**2006 IRC  
Recommended Action for IRC Section R602.10.5  
Continuous Structural Panel Sheathing (Wall Bracing)**

**Lincoln, Nebraska**

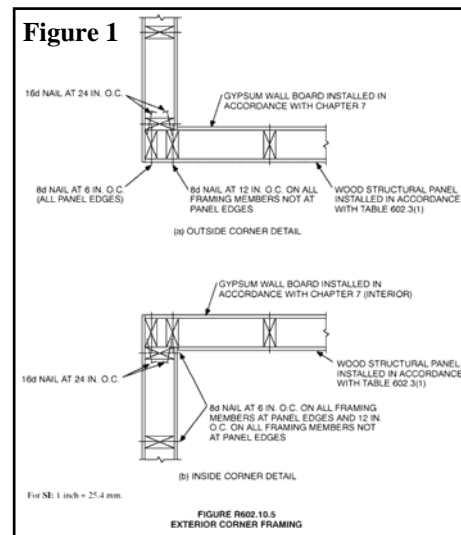
A more appropriate solution to the above concern would have been to clarify that the corner detail in Figure R602.10.5 (see Figure 1 above) requires a minimum 2-foot corner return panel at the ends of a continuously sheathed braced wall line. This would appropriately allow a transition to other bracing methods on other wall lines while also properly adhering to the research data that supports the continuous sheathed bracing method first introduced in the 2000 IRC.
